**MAINTENANCE  
INFORMATION**

**MI13-46**

DATE :	JUNE 2013	SECTION: 06-Electrical
SUBJECT :	DIODE ADDITION TO 24CO CIRCUIT

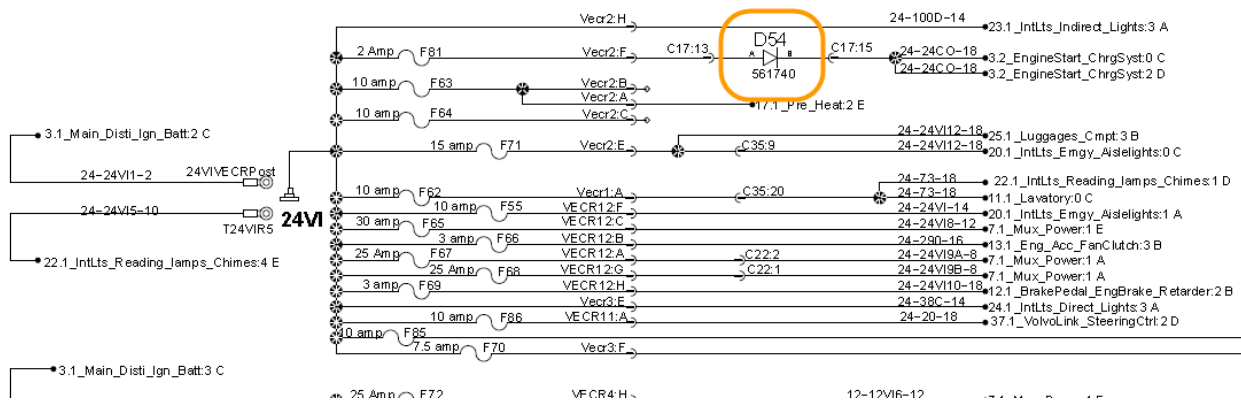
On some post EPA 2010 vehicles, it is possible for the combined charging and starting system F81 fuse to blow unexpectedly.

To avoid this situation, a 3 amp diode can be added to the corresponding 24CO circuit to prevent electrical back-flow to the fuse.

Partial wiring diagram shown as reference (complete wiring diagram of the circuit can be found under # D061140p5.1r7 on the [Prevost Technical Publication](#) web site).

Fig.9 Cut and strip both ends of the wire.

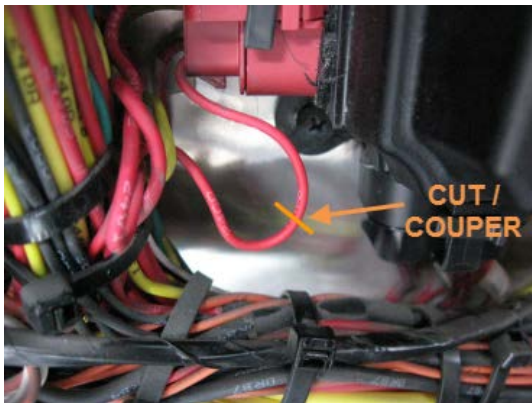
- Cut the 24CO wire at a minimum of 10cm (4 inches) from the connector and strip the protective insulation on both ends (It is not required to unplug the connector but It may be necessary to remove one or more nylon cable tie(s) from the wire harness to get sufficient wire free length).

Fig.10 3amp diode installation.

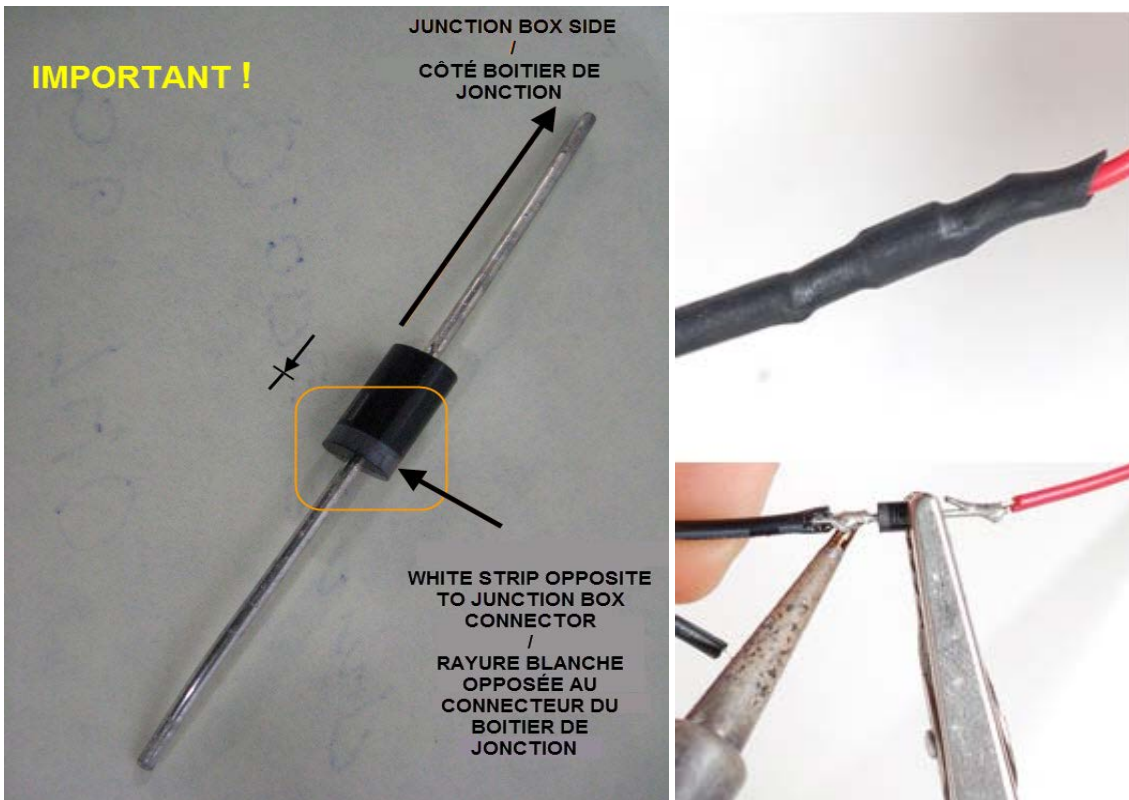
- Insert a 10cm (4inches) length of shrink tubing (#562499 or equivalent) over the harness end of the 24CO wire.
- Solder a 3amp diode between the ends of the stripped wire.

**NOTE: The diode must be soldered with the white strip opposite to the Junction box connector.**

7. Slip the heat shrink tubing over the diode and apply heat to insulate the wire/diode assembly.
